File: DP 15-697654

Re: **Application by Canada Haotian Investment Ltd. for a Development Permit at
8191 Alexandra Road**

Excerpt from the Minutes from
The Design Panel Meeting

DRAWING TITLE
ELEVATION 1

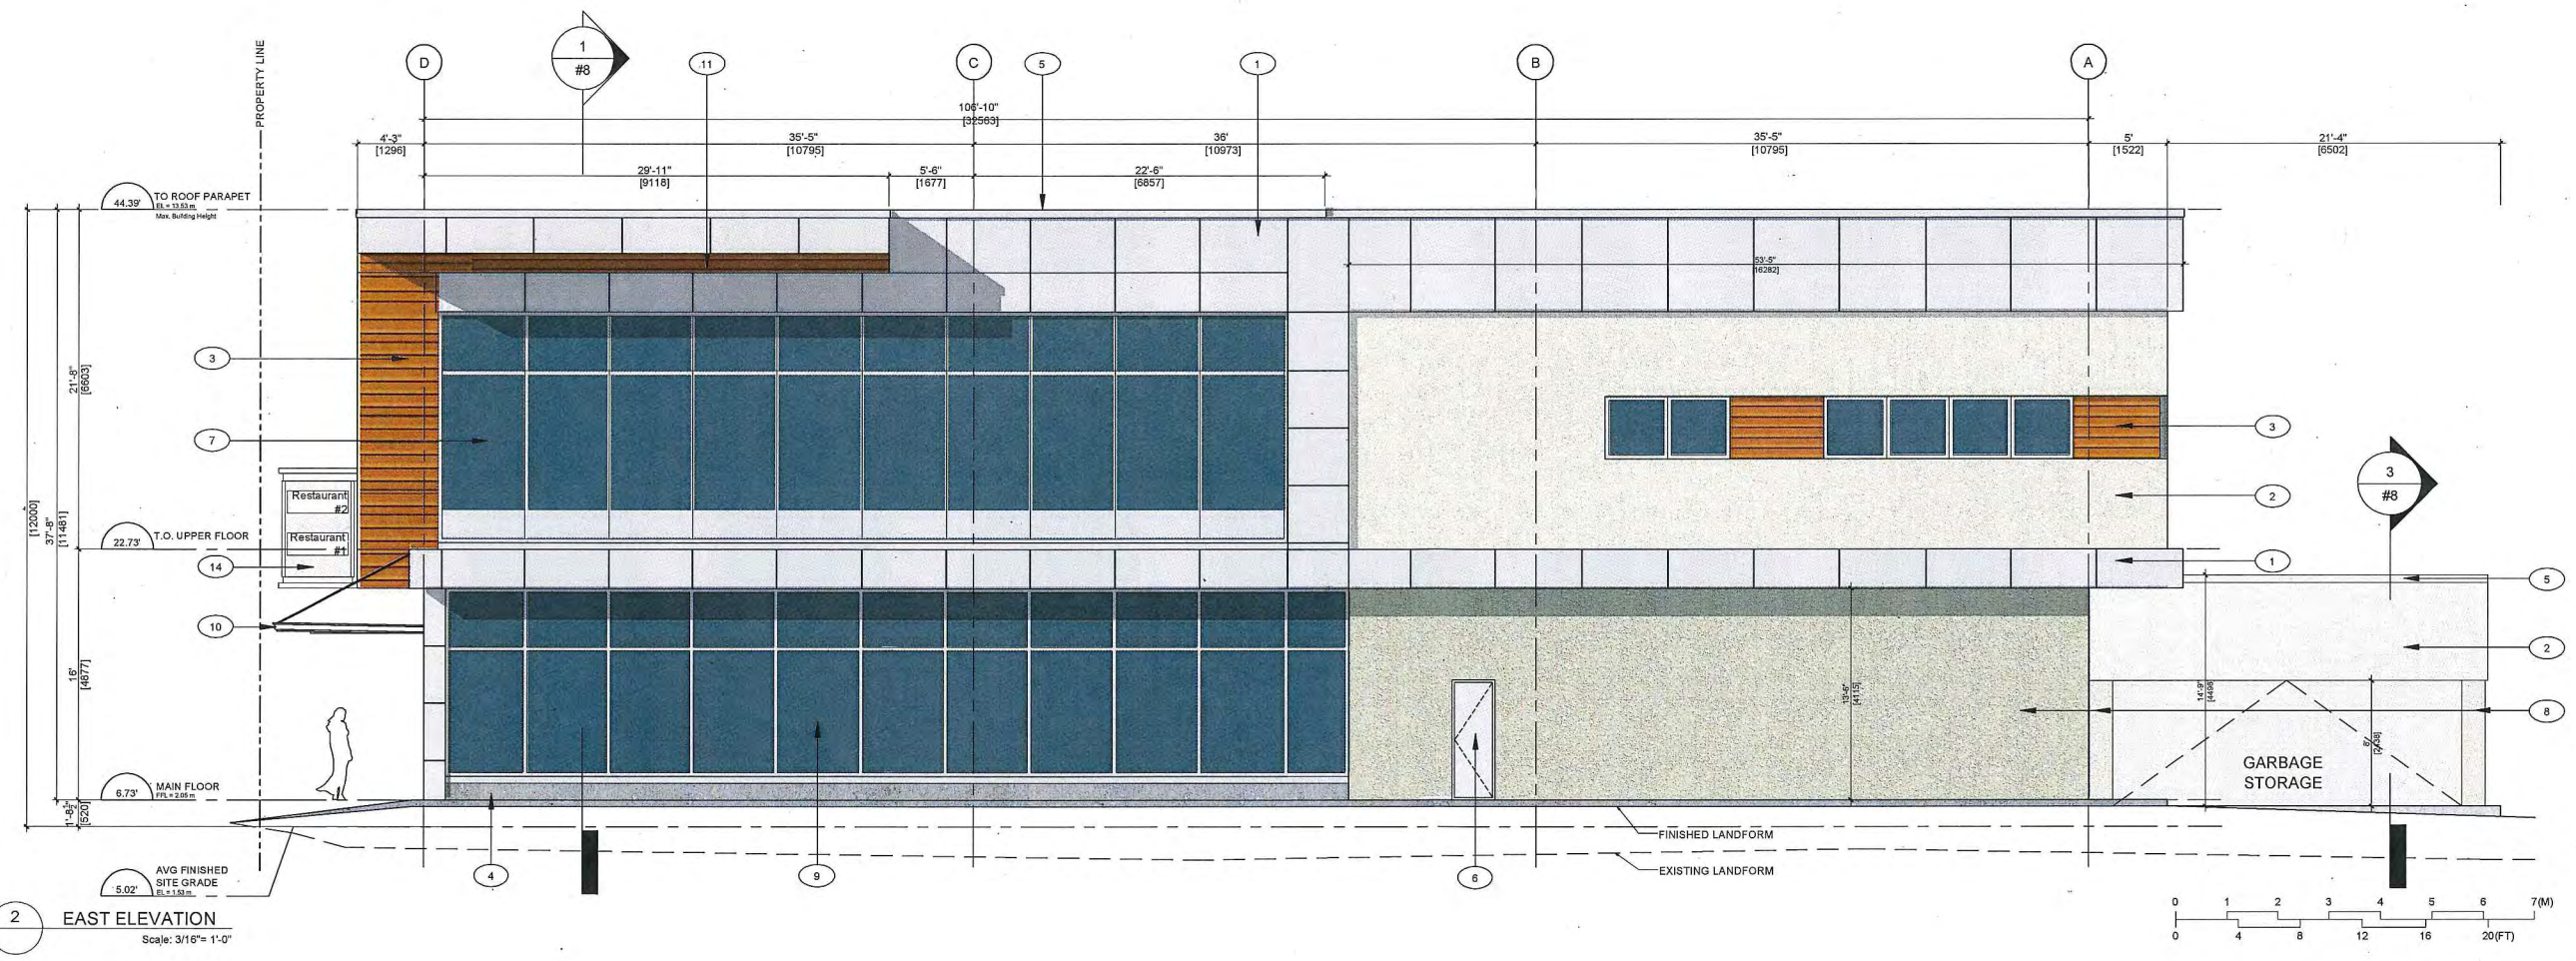
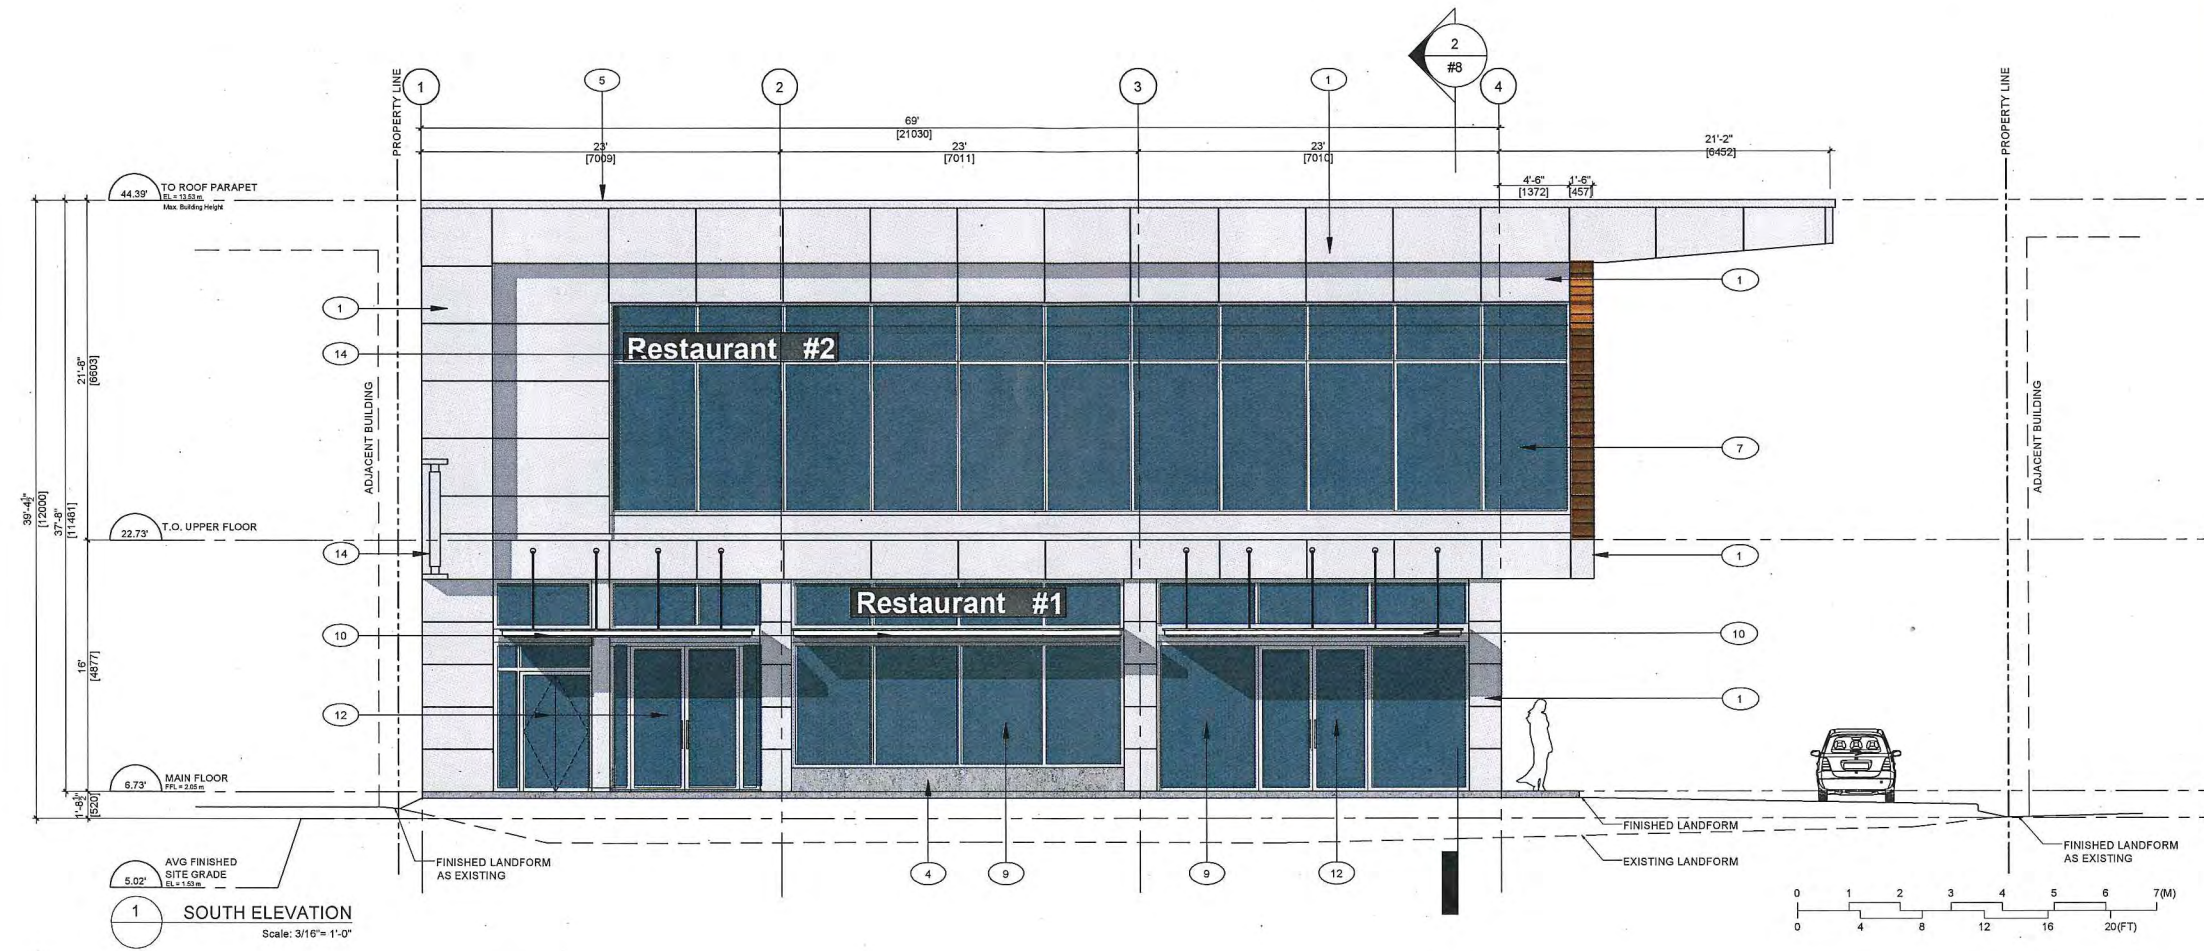
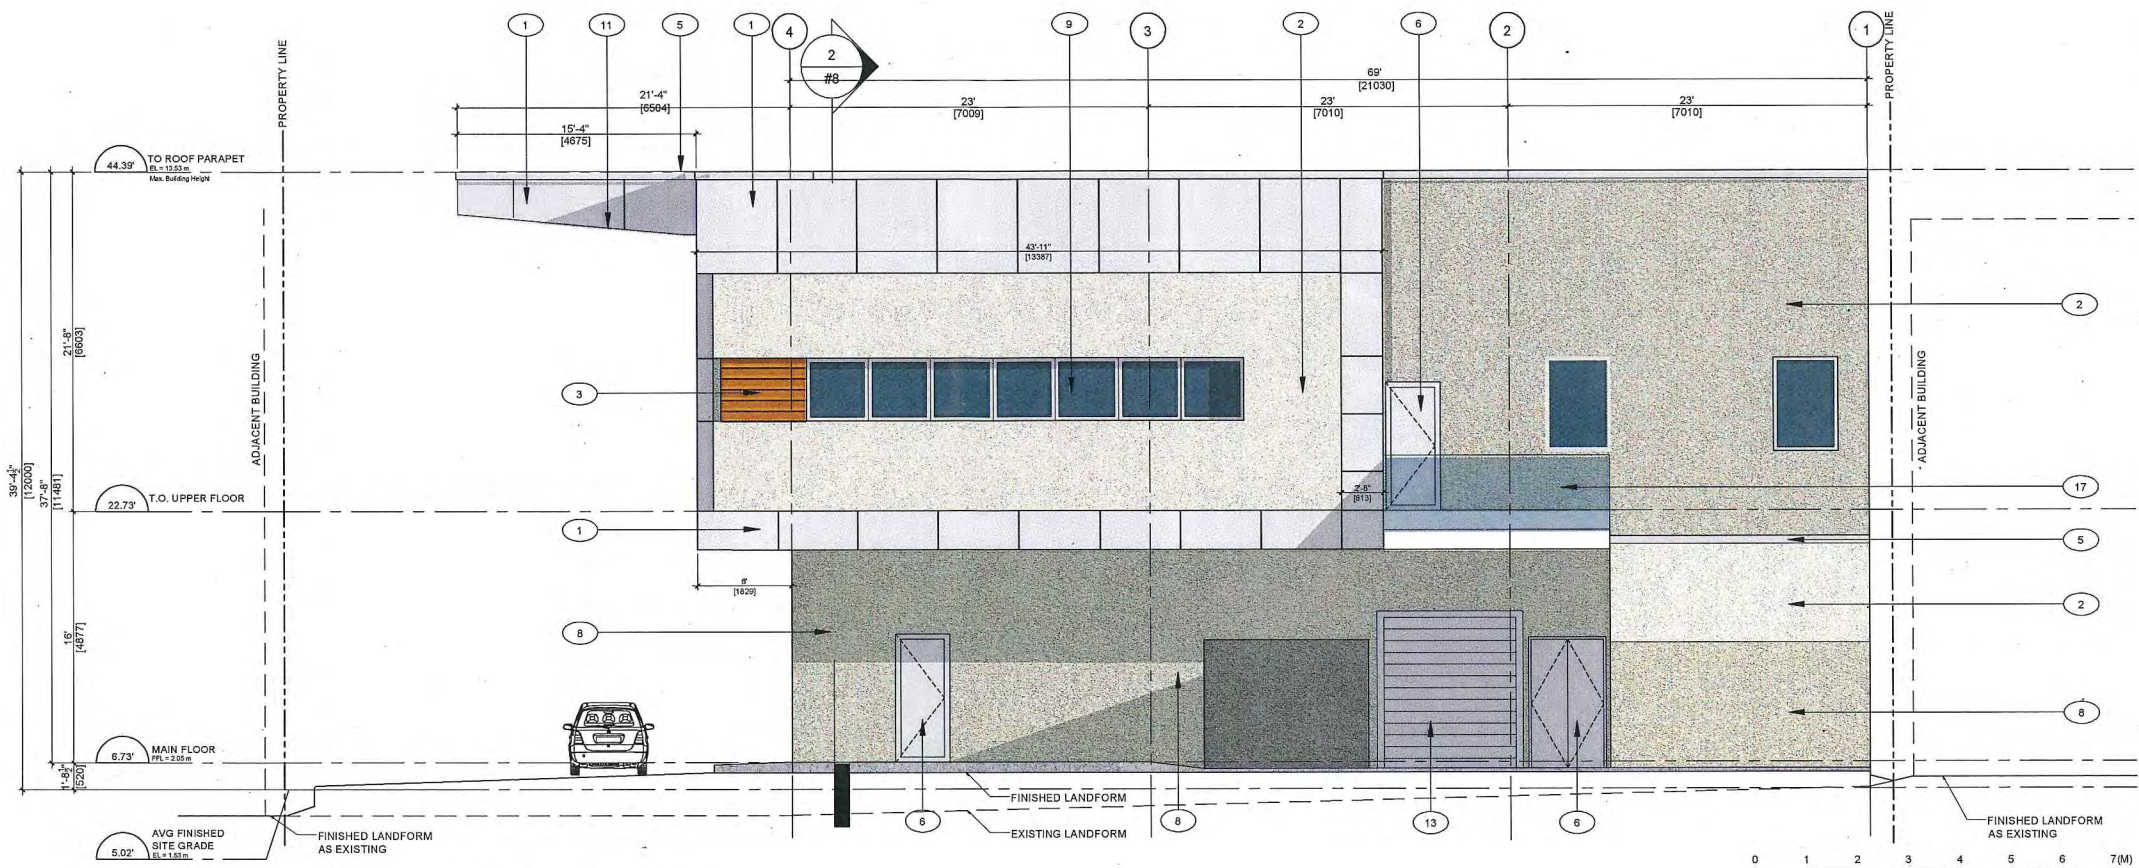
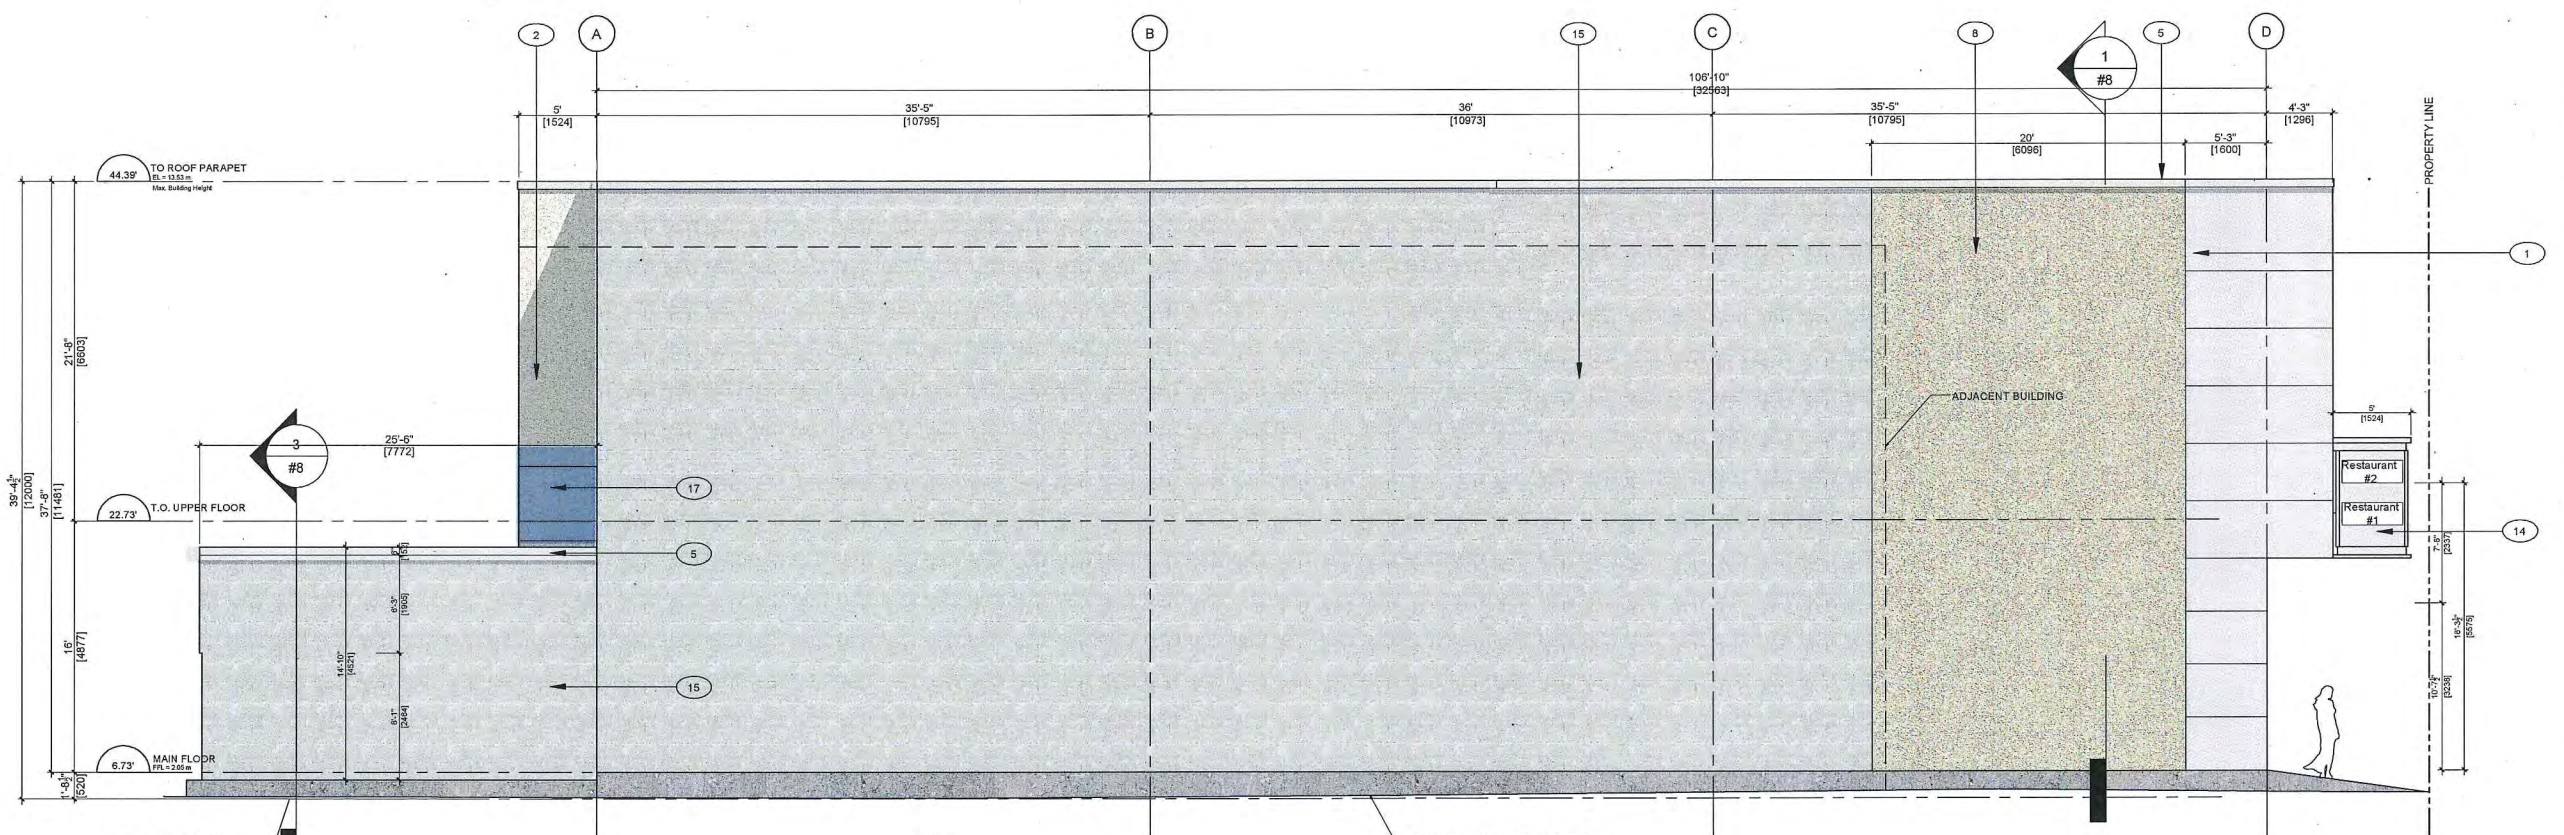
- applicant has adequately addressed the pedestrian scale on the main street; appreciate the front of the building and the overhang; however, the back of the building appears neglected in terms of material treatment;
The metal panels have been extend to the north and west elevations to give additional articulation and interest. Additional wood slats are proposed at back elevations to give a warmer presence to contrast the proposed glass and stucco of the building. The north half of the elevation has been given additional articulation and interest by these material treatments. See architectural elevation drawings.

DRAWING TITLE
ROOF PLAN

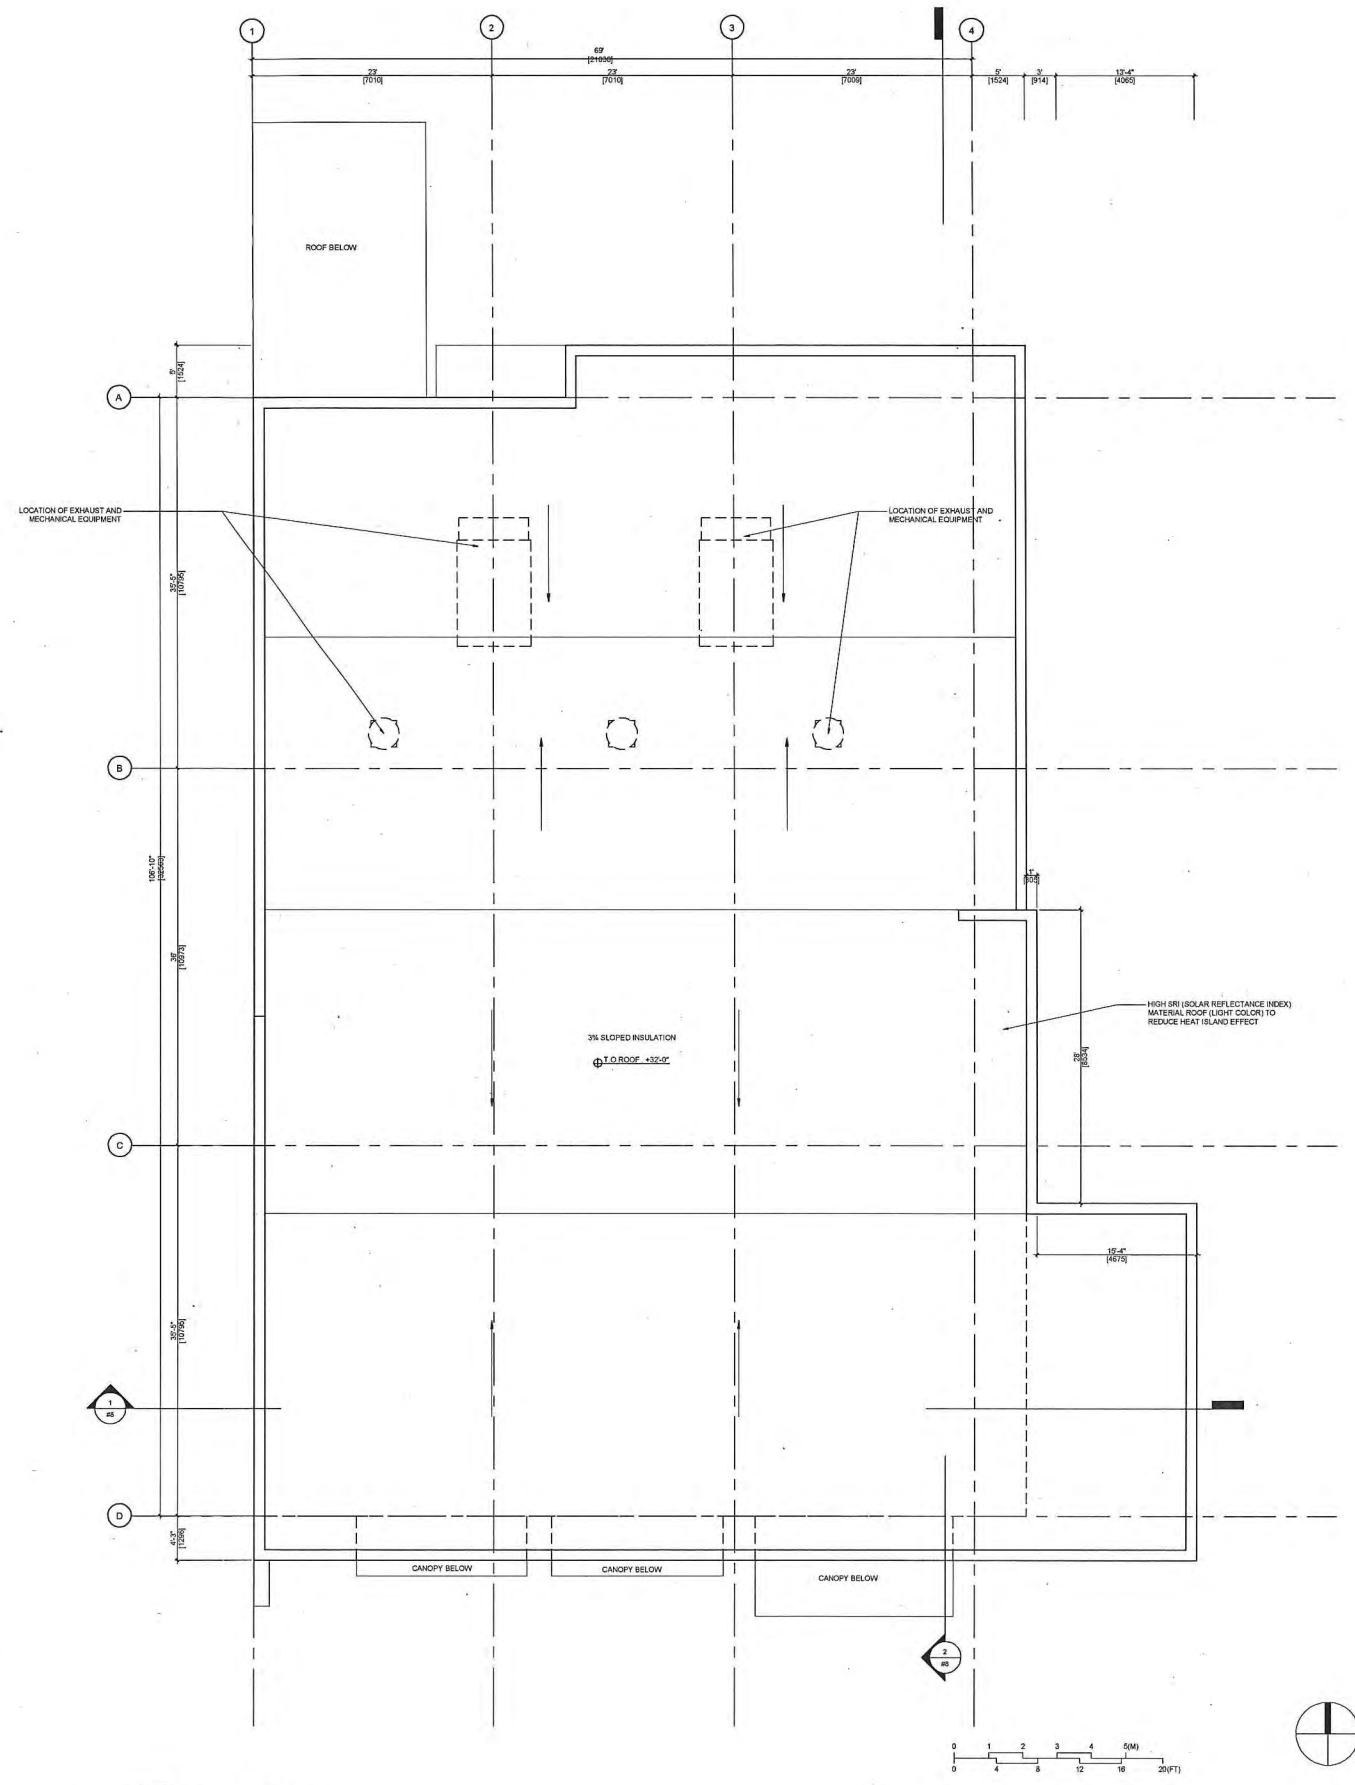
- review the location of the kitchen exhaust to avoid adversely affecting the operations of the adjacent property;
The location of the kitchen exhaust has been reviewed to avoid adversely affecting the operation of the adjacent property. See preliminary layout in roof plan.
